AERONAUTICAL CHARTING FORUM
Instrument procedures Group
April 29-30, 2002
HISTORY RECORD

FAA Control # 02-01-240

Subject: ICAO Holding Pattern Safety Issue

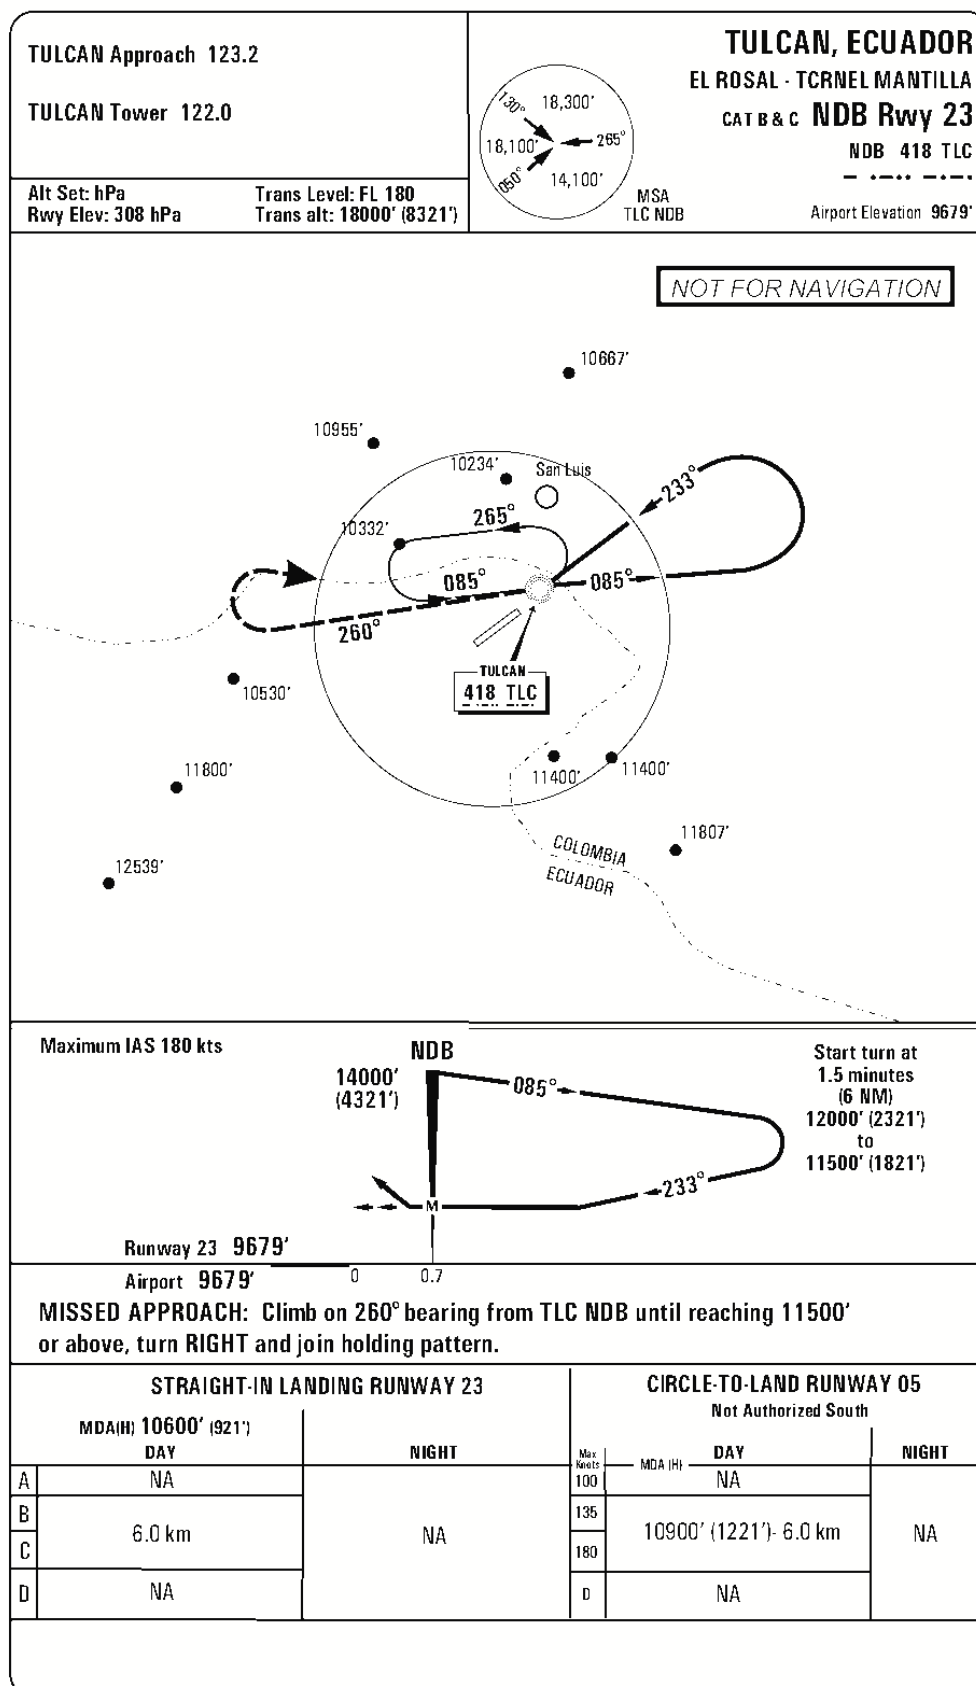
Background/Discussion: This FAA-sponsored forum has previously taken the initiative to attempt to get ICAO to change its concepts for SIAP naming convention and to get world-wide standardization of the naming convention. The January 28, 2002, tragic CFIT crash of an Ecuadorian B-727-100 while flying a holding pattern associated with the NDB instrument approach procedure at the Tulcan, Ecuador Airport (ICAO ID: SETU) reveals serious deficiencies in both the application of holding pattern criteria by some ICAO-member states, and the manner in which critical procedural data notes lack standardization, both as to verbiage and charting placement. The human-factors implications all aspects of the procedural construction and charting results at Tulcan are abysmal.

Apparently, the designer of the Tulcan NDB IAP elected to constrain the holding pattern to 180 knots, with a minimum holding altitude of 14,000 feet. In the United States, such a pattern would have to be the standard 230-knot pattern to be authorized for jet airplanes. These United States criteria are based on valid aerodynamic premises. It appears that PANS-OPS terminal instrument criteria are open to more conjecture, at least as to holding pattern design, than are U.S. TERPs. It is apparent, though, that the standard application of PANS-OPS criteria would have dictated a 240-knot pattern at Tulcan above 14,000 feet, and a 230-knot pattern at 14,000 feet.

Recommendation: That this forum initiate the necessary actions to cause the United States representatives to ICAO to modify PANS-OPS holding pattern criteria and associated procedural text to: 1. Deny construction of holding patterns for jet airplanes with speeds less than standard, for altitudes above 10,000 feet. For altitudes 10,000 feet, and below, and where an operational requirement exists, deny a speed reduction for jet airplanes of less than 200 knots. Where a unique requirement exists for lower speeds, such IAPs should not be issued to the public; rather they should be similar to our "specials" and issued only to carriers with a demonstrated need and proven qualifications. 2. That PANS-OPS be clarified to require any non-standard holding speed limit to be associated directly with the holding pattern's plan view icon (and in the profile view as well where an affected holding pattern is charted in the profile view. 3. That PANS-OPS be clarified to require the charting of the minimum holding altitude in a clear and unmistakable manner adjacent to the holding pattern icon.

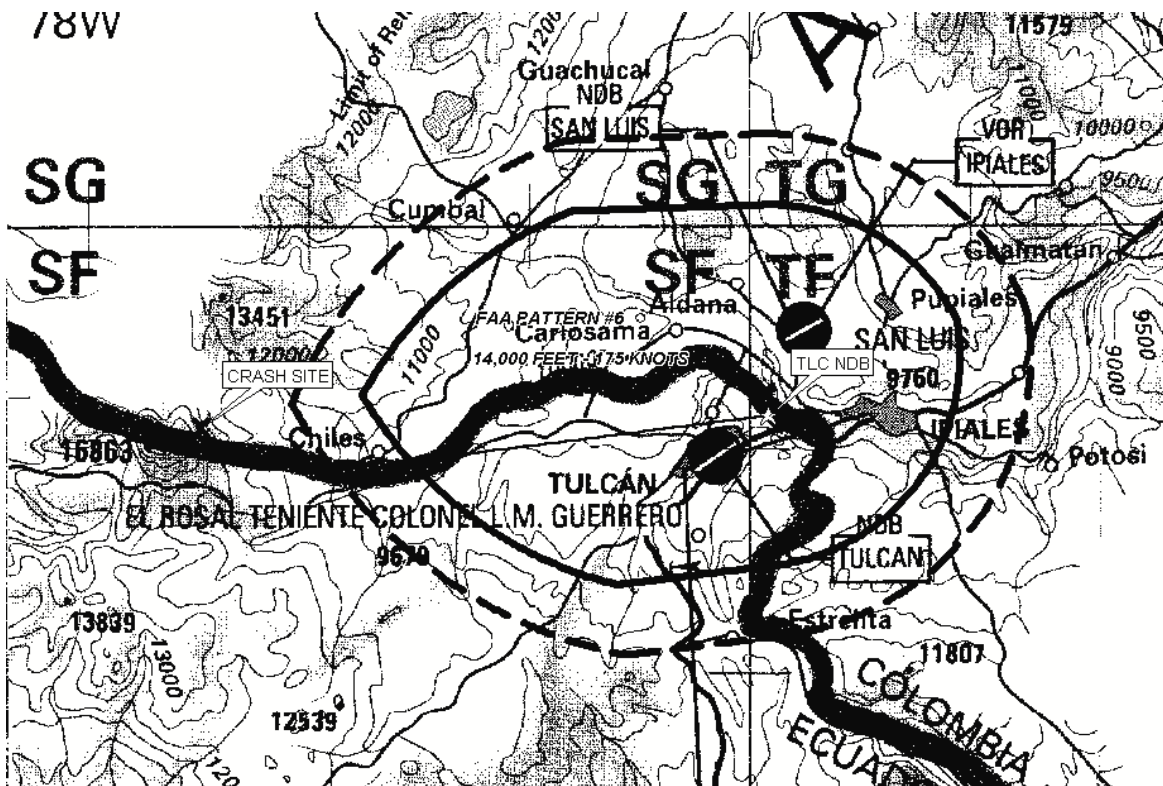
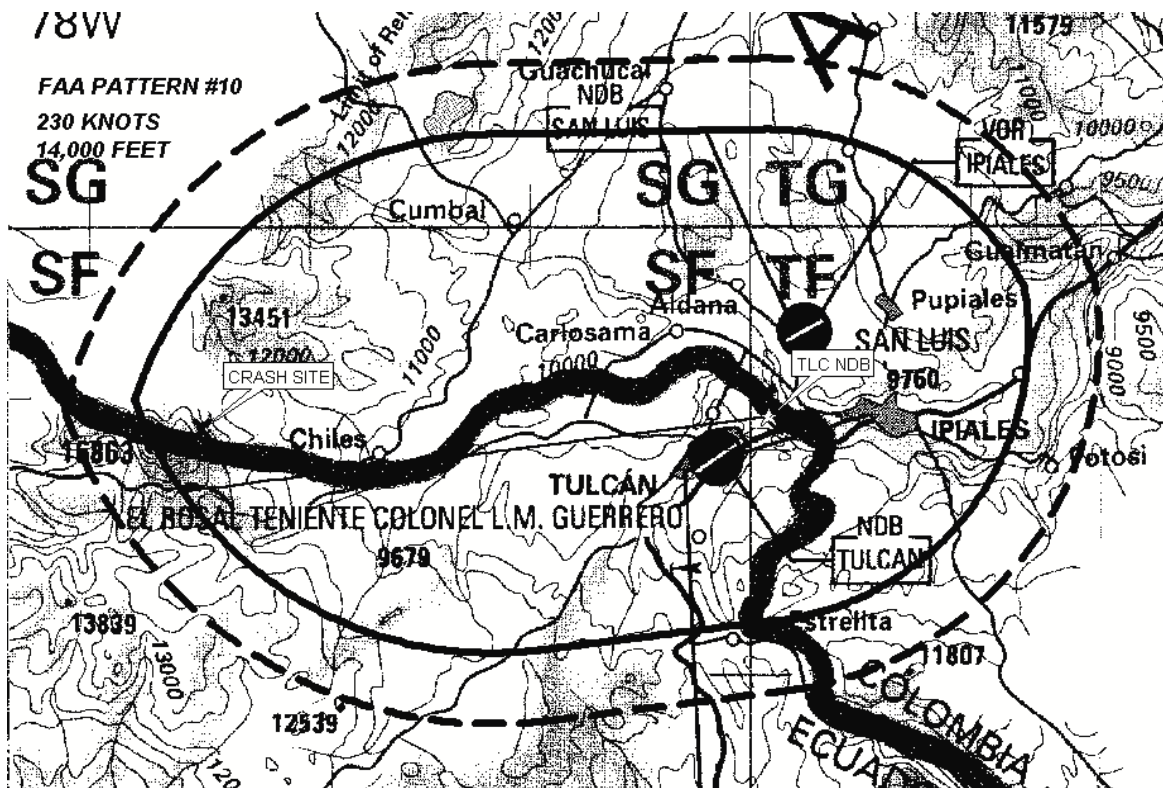
On the attached pages are a generic graphical representation of the Tulcan NDB IAP as it appeared on the date of the accident, as well as graphics of the topography for the area with placement of TERPS 230 and 175-knot holding templates for 14,000 feet. Note that the only reference to a speed limit is in the profile view of the approach chart, which most pilots would associate with the base leg outbound as shown in the profile view. Note also there is no minimum holding altitude shown in the plan view.
